WSR 23-02-025

PERMANENT RULES

WAC 51-51-0403 Section R403—Footings.

Figure R403.1.1(1)
Alternative Minimum Footing Size for Light-Frame Construction
a, b, c, d, e, f, g, h, i
20 PSF Snow Load

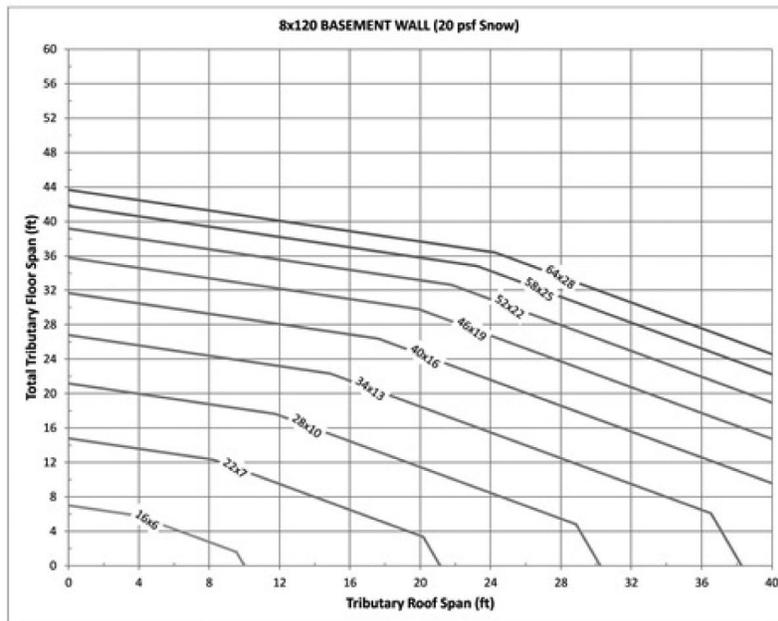
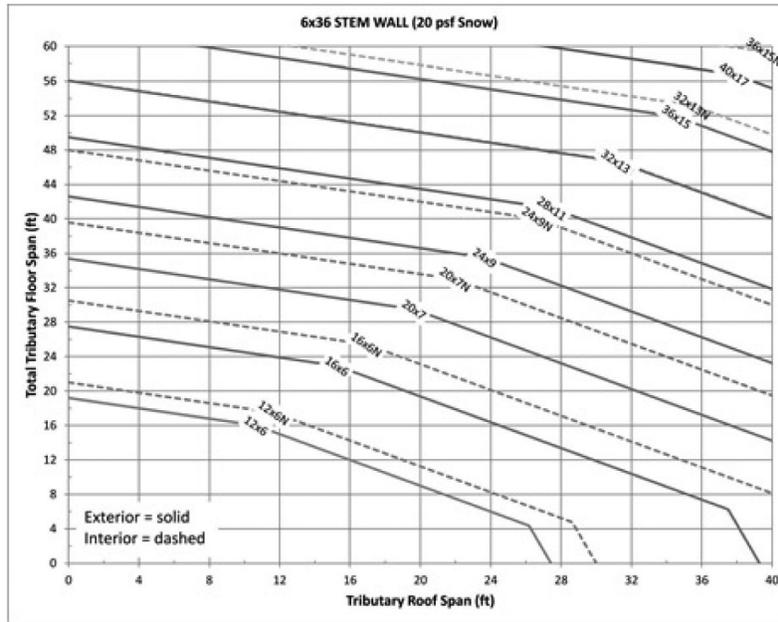
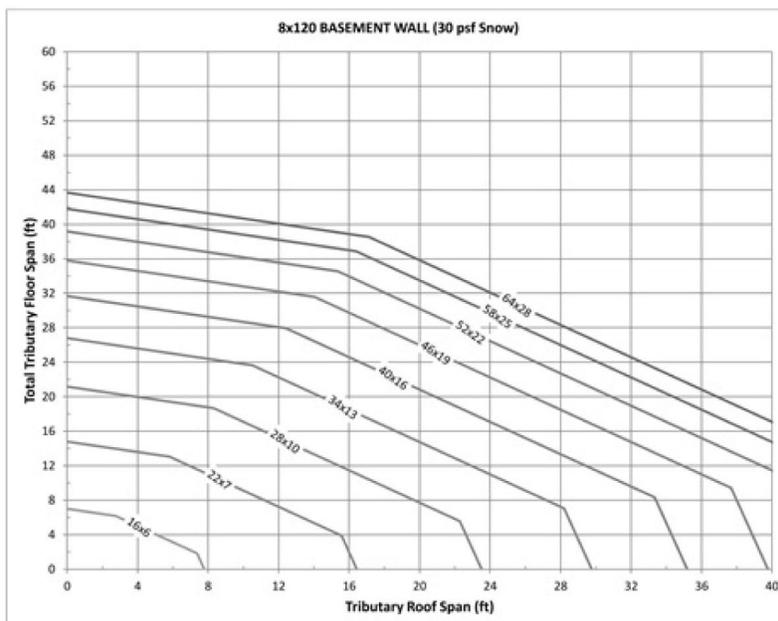
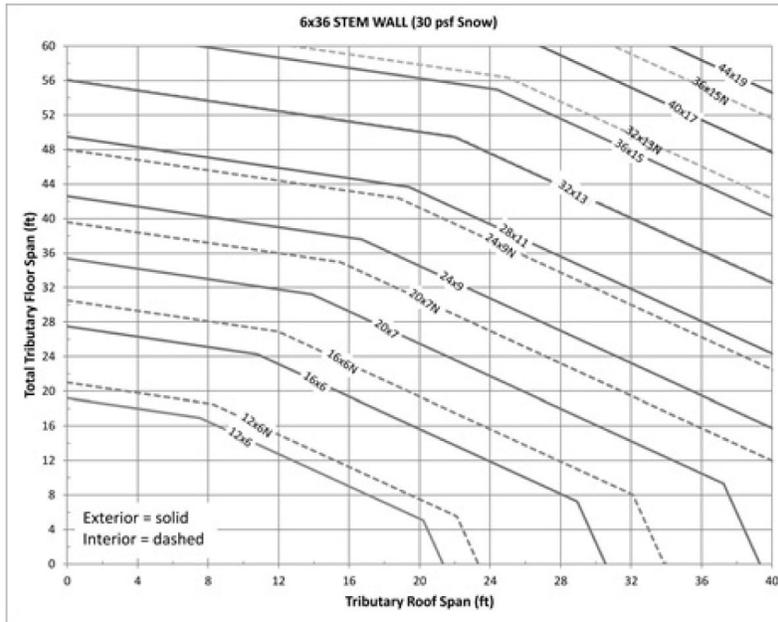
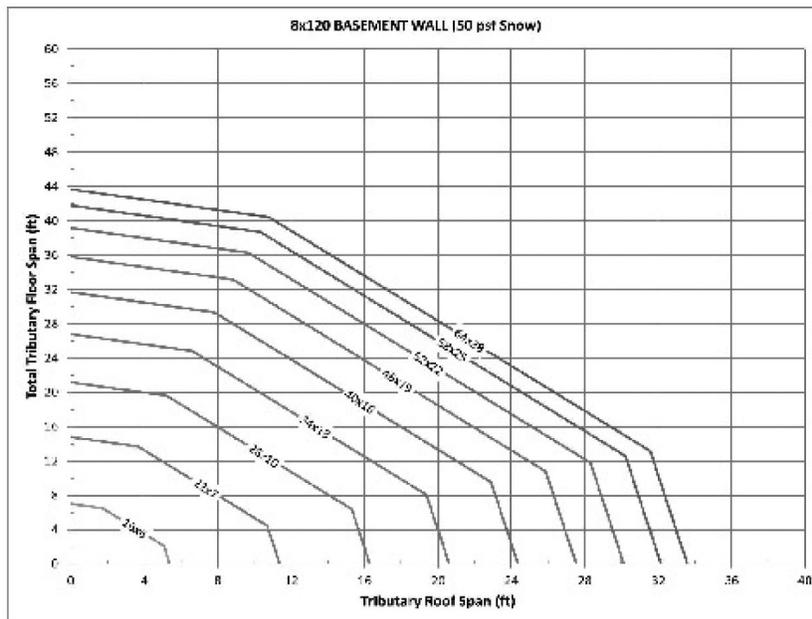
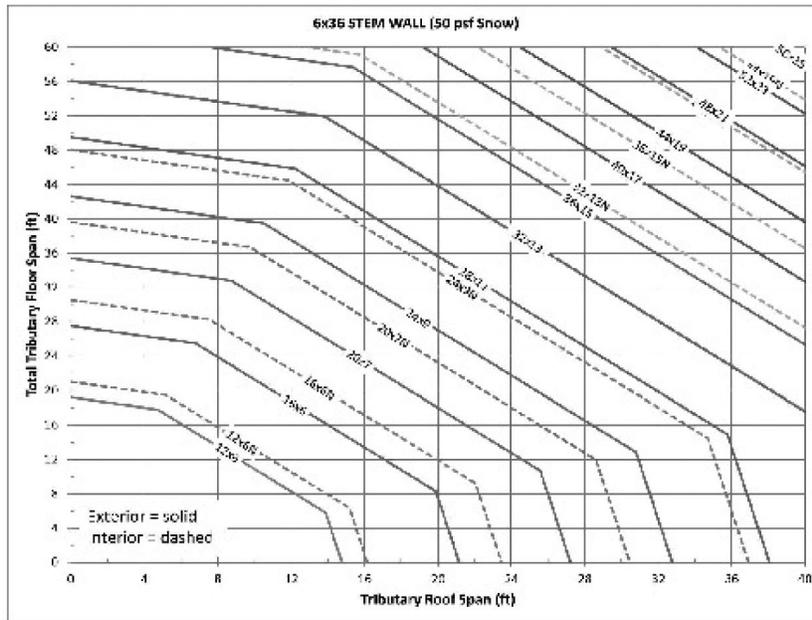
EXCEPTION: Light-frame construction shall be permitted to have minimum footing size in accordance with Figures R403.1.1(1) through R403.1.1(4) in lieu of that determined by Table R403.1(1).
